Staff Report 2021-0406

Subject: Design Plan Services Inc. on behalf of Jannett and Richard Nichalson and 2683894 Ontario Inc., 0 and 18314 Hurontario Street, Caledon Village, Ward 1

**Application for Zoning By-law Amendment,
Plan of Condominium & Site Plan Approval
RZ 2021-0001, 21CDM-21001C & SPA 2021-0001
Design Plan Services**

Re: Application for Draft Plan of Condominium and Zoning By-law Amendment
Design Plan Services Inc. on behalf of Jannett and Richard Nichalson and 2683894
Ontario Inc.
0 and 18314 Hurontario Street
Part Lot 1, Concession 1 (WHS) Caledon, Designated as Part 1 of Plan 43R-7750
File No.: 21CDM-21001C and RZ 2021-0001

DRAFT PLAN OF CONDOMINIUM

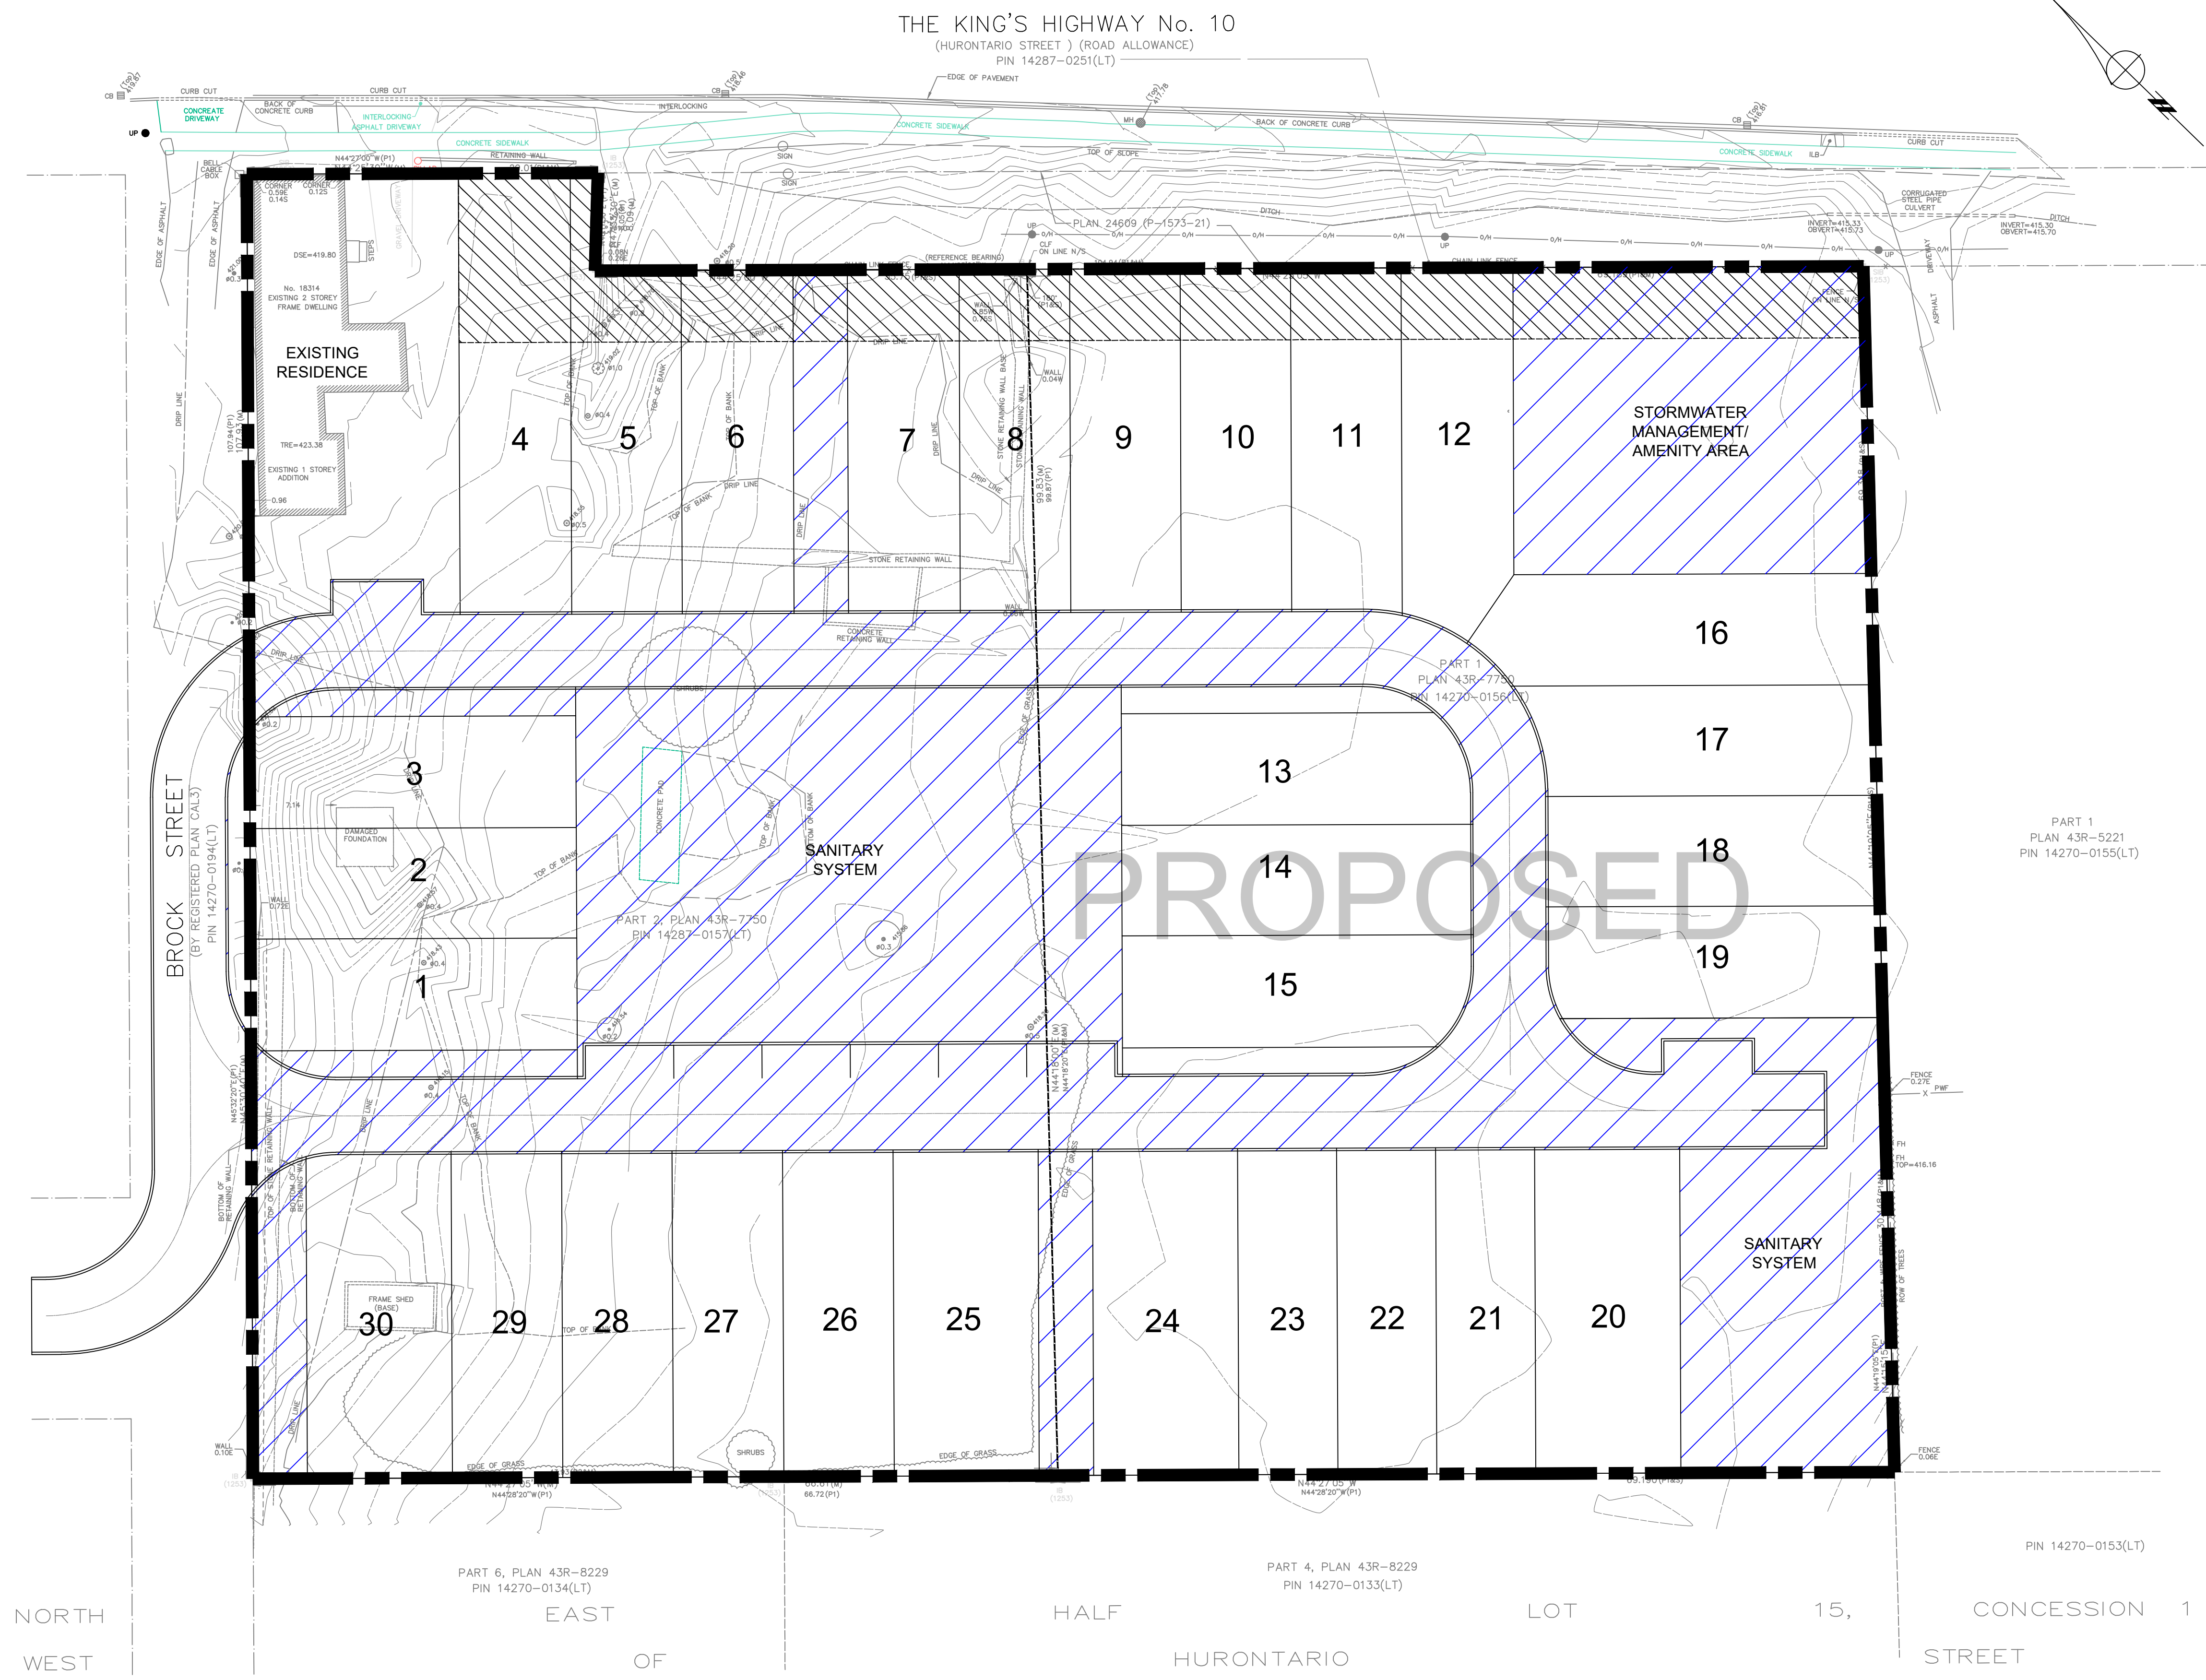
21. Building areas, lot areas and lot frontages (as defined by 2006-50, as amended) for each townhouse dwelling units could not be confirmed. Please include a draft plan indicating all

applicable building areas, lot areas and lot frontages for each dwelling proposed. *(Town of Caledon, Planning Department, Zoning)*

28. Staff request that draft condominium plans be provided to facilitate the review of the proposed condominium development. *(Town of Caledon, Planning Department, Zoning)*

DRAWING TITLE:
PRELIMINARY LANDSCAPE MASTER PLAN

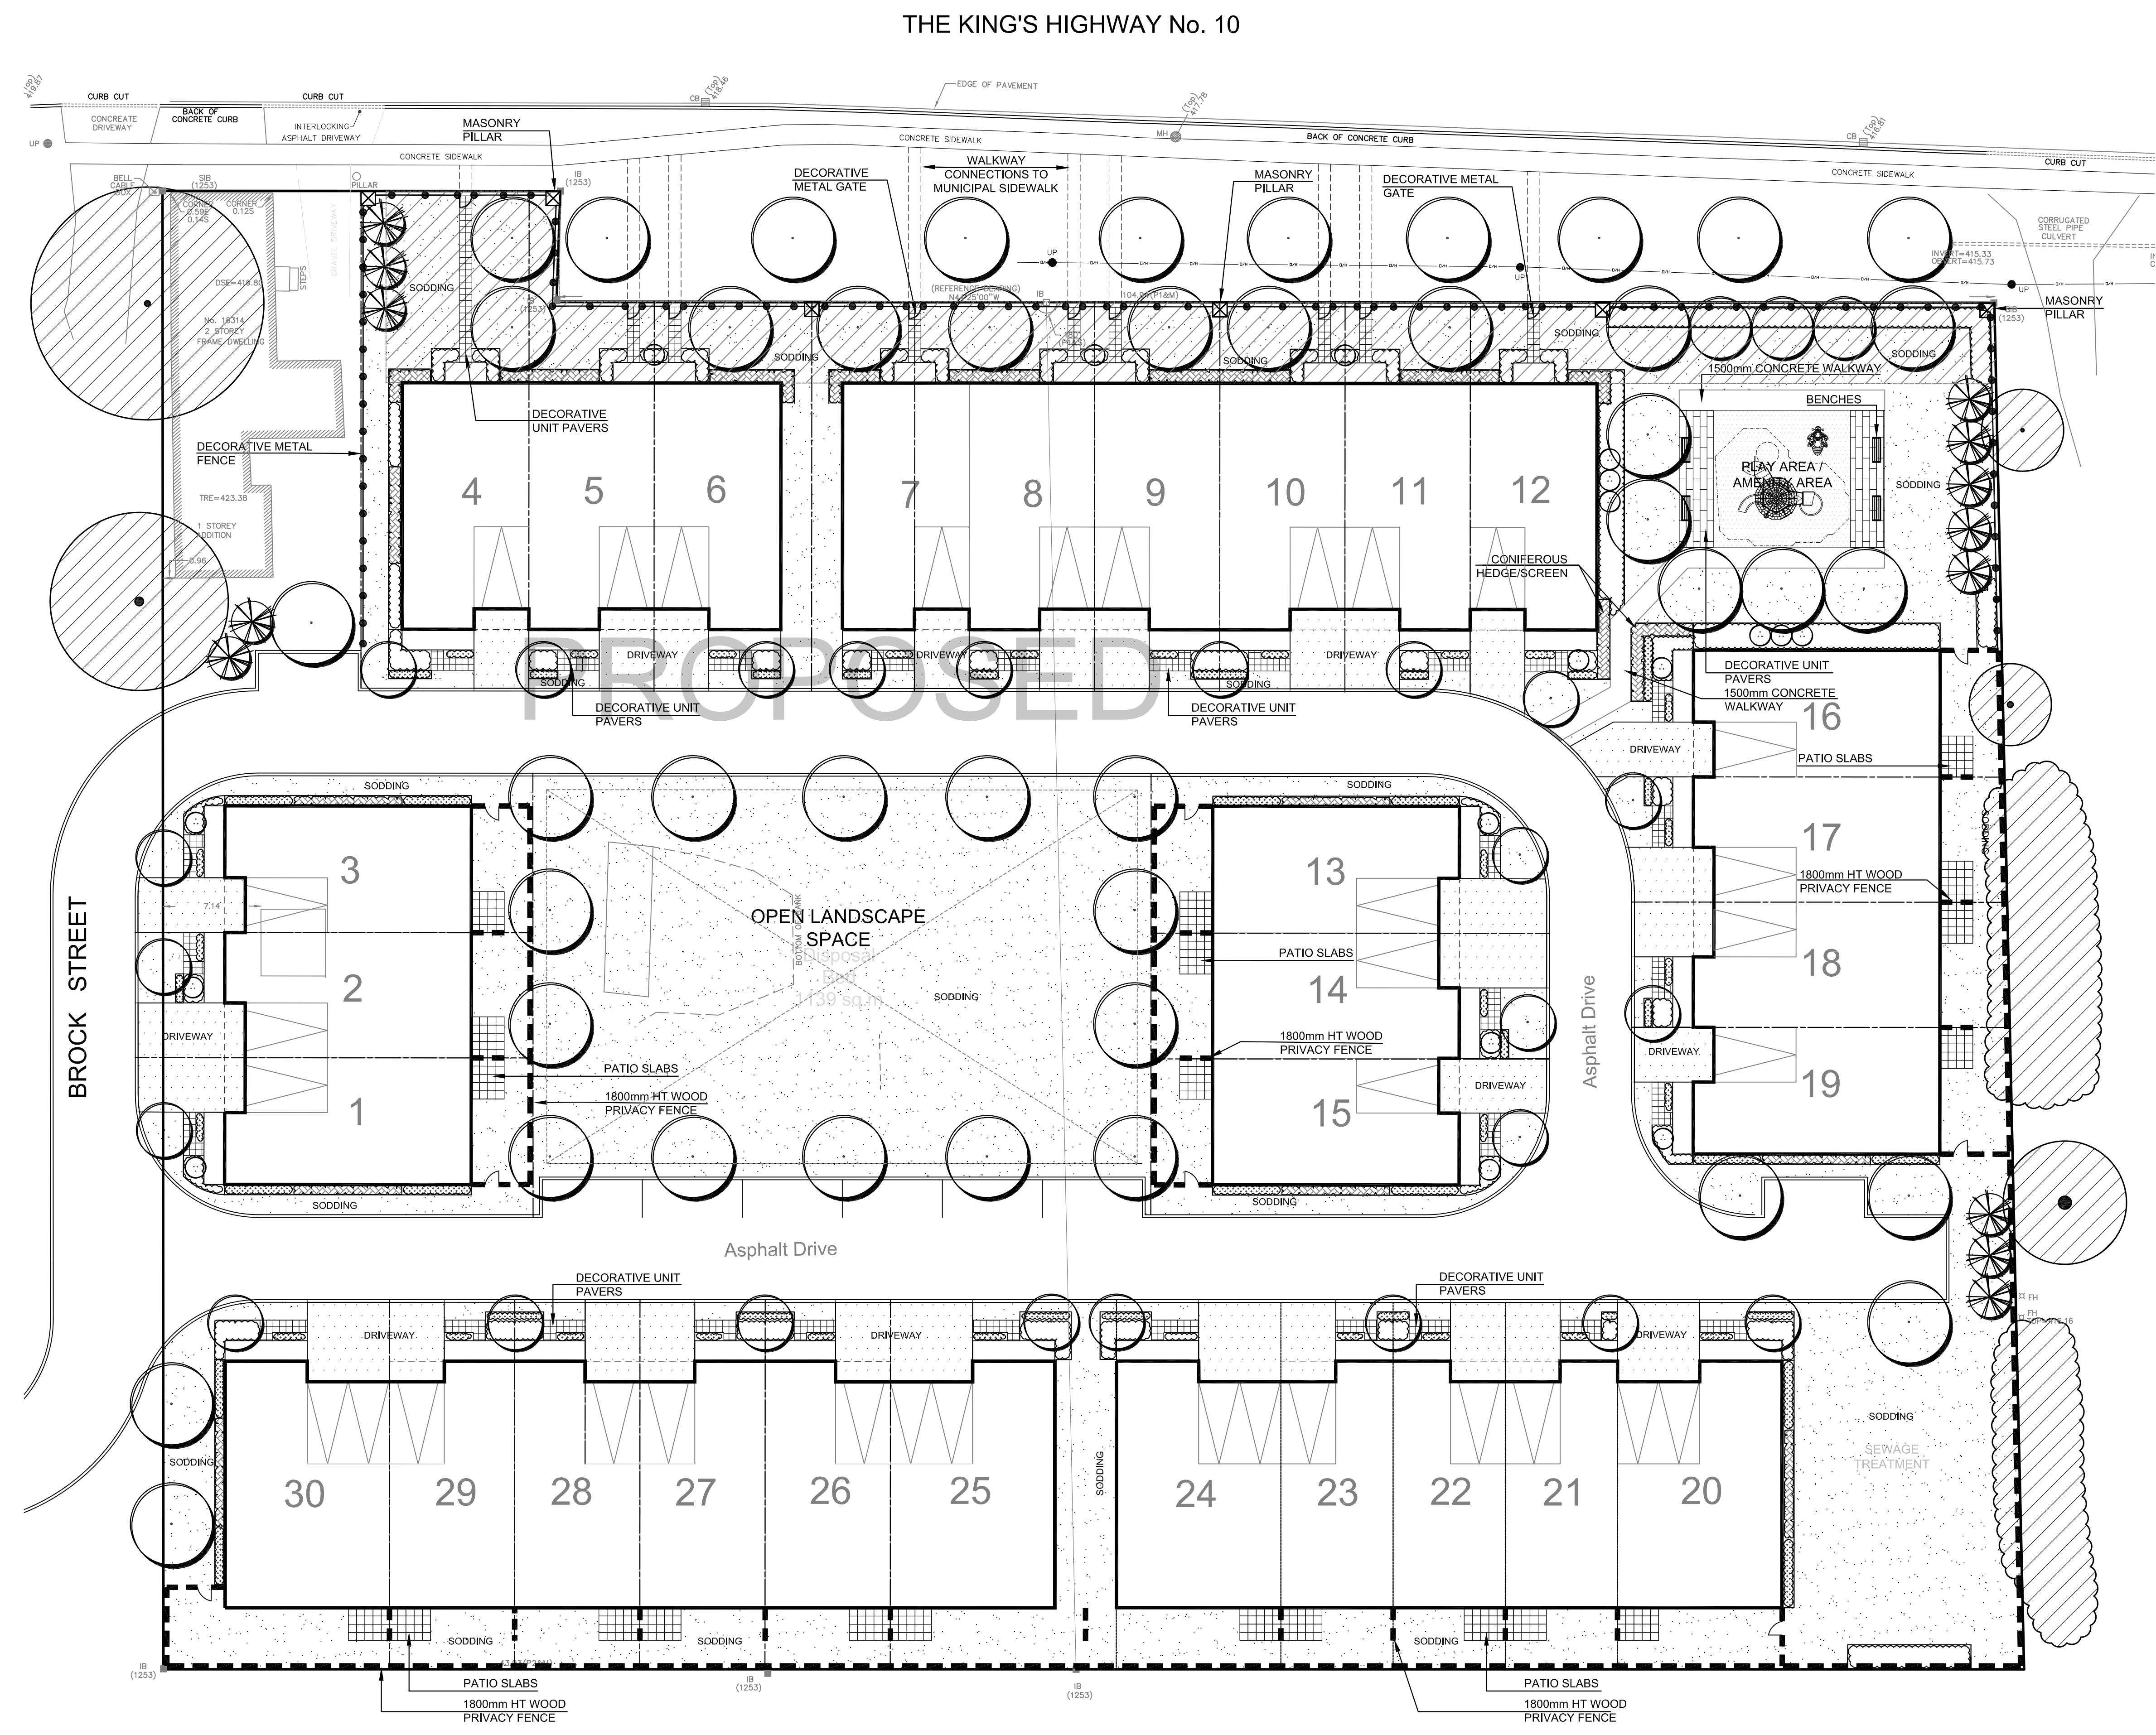
41. Credit Valley Conservation (CVC) staff recommend that the following items relating to ecology are addressed in a future resubmission:
- a. All relevant plans (Landscape, Tree Preservation, etc.) should be updated to acknowledge the Migratory Bird Convention Act and ensure that vegetation removals do not occur between April 1 - August 31. (*Credit Valley Conservation Authority*)

14. Pg. 7 – Update Figure 7 (Landscape Master Plan) as per comments to the Site Plan and Preliminary Landscape Master Plan.
15. Pg. 9 – Update Figure 8 (Fencing Plan) as per comments to the Site Plan and Preliminary Landscape Master Plan. Ensure coordination between Noise Report and Landscape Plan (i.e. clarify fencing treatments along units 4-12, etc.).
